# Access Compliance Report

## Public Rights-of-Way

Intersection ID: 51011	Main Street: TREMONT_PLACE_RD	Cross Street: BENDING_BRANCH_RD	Location: E
ADA ID: EA843DF9C985	Ramp Type: Perp	Initial Pass/Fail: Fail	Overall Compliance: No
Severity Score: 22.5			
Codes/Mitigation Info/Possible Solution		Field Measurements/Component Compliance

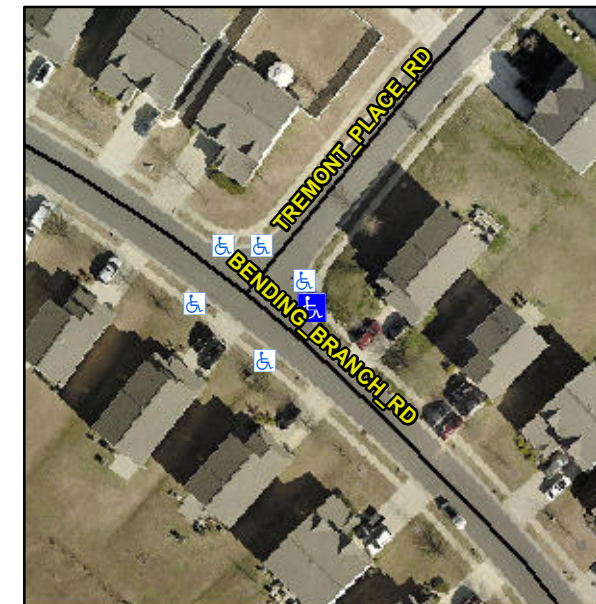
**Not Found, R304.5.1, R304.2.2**

Compliance	Description	Data	Compliance	Description	Data
N/A	Ramp Length (in)	49.0	No	Ramp Slope (%)	8.4
No	Ramp Width (in)	47.5	Yes	Ramp XSlope (%)	3.2
N/A	Flare Type LT	N/A	N/A	Flare Type RT	N/A
N/A	Flare Slope LT (%)	N/A	N/A	Flare Slope RT (%)	N/A
N/A	Flare Traversable LT?	N/A	N/A	Flare Traversable RT?	N/A
N/A	Landing Length (in)	N/A	N/A	DWS Provided?	N/A
N/A	Landing Width (in)	N/A	N/A	DWS Contrast?	N/A
N/A	Landing Slope (%)	N/A	N/A	DWS Length (in)	N/A
N/A	Landing X Slope (%)	N/A	N/A	DWS Full Width?	N/A
N/A	Landing Curb? (Y/N)	N/A	N/A	DWS Offset (in)	N/A
N/A	Shared Landing?	N/A			
N/A	Gutter Ponding?	N/A	N/A	Gutter Slope (%)	N/A
N/A	Gutter Lip Ht (in)	N/A	N/A	Gutter X Slope (%)	N/A
N/A	Painted X Walk1?	No	N/A	Painted X Walk2?	N/A
	X Walk 1 Direction	To SW		X Walk 2 Direction	N/A
N/A	X Walk 1 Width (in)	N/A	N/A	X Walk 2 Width (in)	N/A
	X Walk 1 Slope (%)	2.4		X Walk 2 Slope (%)	N/A
	X Walk 1 X Slope (%)	3.2		X Walk 2 X Slope (%)	N/A

**Remove & Replace Entire Ramp.**
